LEAK OF RADIOACTIVE LIQUOR IN THE FEED CLARIFICATION CELL AT BNG THORP SELLAFIELD

REVIEW OF THE MANAGEMENT AND TECHNICAL ASPECTS OF THE FAILURE AND ITS IMPLICATIONS FOR THE FUTURE OF THORP

CLIENT: GREENPEACE INTERNATIONAL

REPORT REF N° R3123-A2

Accountancy Tank B – Nozzle Failure

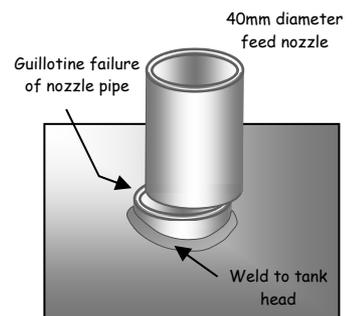
Following the detection of the leak, an internal BNG Board of Inquiry reported in May 2005² states that remote cctv inspection of Cell 220 revealed a significant quantity of dissolver liquor in the base of the cell and that a feed pipe to one of the accountancy tanks (Tank B – nozzle N5) had failed by fatigue fracture at a location close to the head of the vessel.

The failure of the feed nozzle is in the form of a complete guillotine break of the 40mm diameter feed pipe just above the pipe to tank welded joint, with the disconnected pipe remaining slightly misaligned above the stub of the pipe. Because of this alignment, the gravity flow of the clarified feed liquor continued to run into the tank, with some of the flow splashing out and running down the tank side, spilling onto sections of the supporting steel frame.

i) Tank B Repaired - Returned to Full Operation

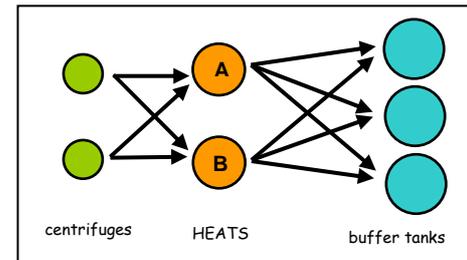
Repair Tank B remotely and restore the system but with design and process management revisions.

Remote working within the cell (i) would require enlarging the access portal into the cell, presently limited to a 300mm diameter access hole and then, robotically, implementing repairs and modifications to the nozzle connections and steel frame.

iii) By-Pass Both Accountancy Tanks A & B

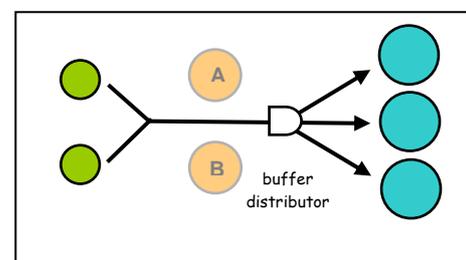
In this option, both accountancy tanks (A and the damaged B) are by-passed with the centrifuged or clarified liquor being fed to any one of the three downstream buffer tanks, with the bypass piping either feeding by gravity or being pumped to the existing buffer tank distributor.

To bypass the remaining accountancy tank (iii) requires remote installation of new pipework directly from the centrifuge, either gravity fed or pumped to the buffer tanks, with the former option possibly resulting in a 20 to 30% reduction of batch throughput because of the height limitations for gravity feeding in the cell.¹⁸ Removal of the accountancy tank process stage requires modification of the head-end process overall to introduce a new weighing stage¹⁹ and plutonium valency conditioning.¹

iv) Accountancy via Tank A Only

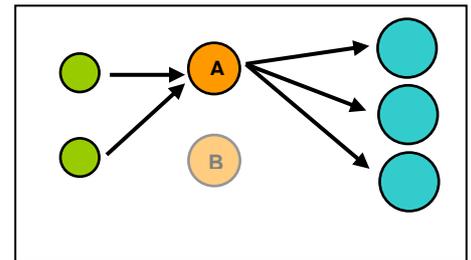
The damaged accountancy tank B is abandoned and the process continues operating only via the present Tank A, albeit with the amended procedure that the tank would only be lifted and suspended when weighing is required.

The use of just one accountancy tank would reduce THORP operational throughputs from in excess of 5 tonnes per day to 3 tonnes per day.

Even if the present continuous suspension mode for accountancy weighing is abandoned, further use of Tank A must be conditional on the fit-for-purpose condition of its nozzle and pipe connections. Before this option can proceed, these connections will have to be robotically inspected and subject to non-destructive examination. This is because Tank A has been in service and subject to the same conditions that failed the N5 connection to Tank B with at least the Tank A N5 connection being subject to the same number of sway and oscillatory fatigue cycles as its failed counterpart.²⁰

v) Tank A as Intermediate Stage Only

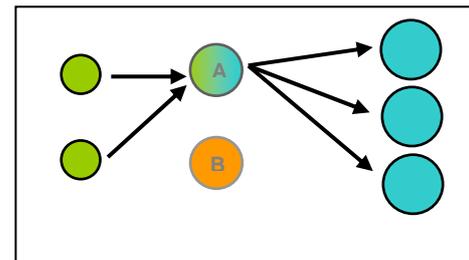
Tank A is utilised as a pump-through reservoir with accountancy being undertaken in the buffer tanks which enables the 5 tonne daily throughput to be maintained.

Tank A remains in use as a collecting and pump through reservoir, with accountancy being completed in the buffer tanks, thereby maintaining the 5 tonne daily throughput for THORP.

APPENDIX I – FRAME DAMAGE

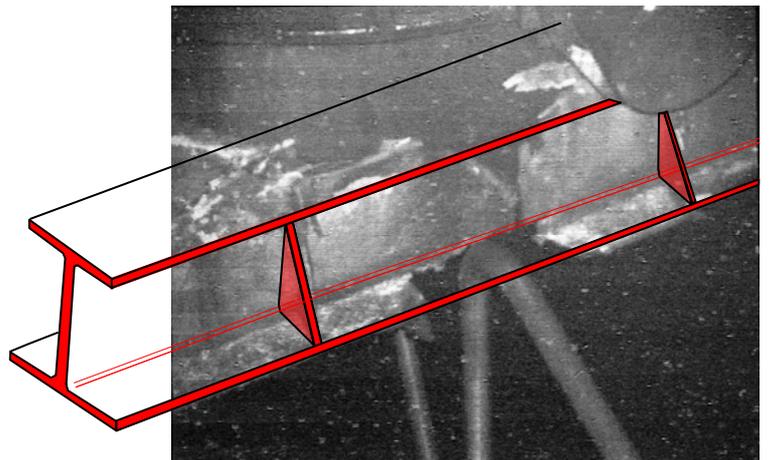
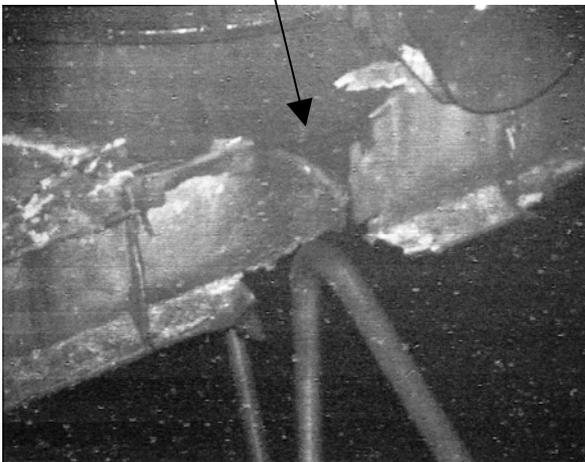
Over the period of the leak, perhaps for about 9 months, the carbon steel frame sustained significant corrosion, with the spilling nitric acid etching into and completely eroding through the higher and lower south sections of the frame, including the 600mm wide web of the main I-beam at the lower level.

The damage to the steel frame appears to be extensive⁷ and repairs, even if possible by remote means operating within the cell, would require opening up the cell access hole which is presently only 300mm diameter to receive new sections of the 600mm web I-beam.

- 7 The steel frame sections (I-beams) are only protected with paint and thus very susceptible to corrosion by the strong nitric acid content of the spilled clarified liquor. The extent of corrosion is given by some poor quality photographs in the NDA Review (11) which shows sections of both higher and lower level beams completely eroded through – Appendix 1.
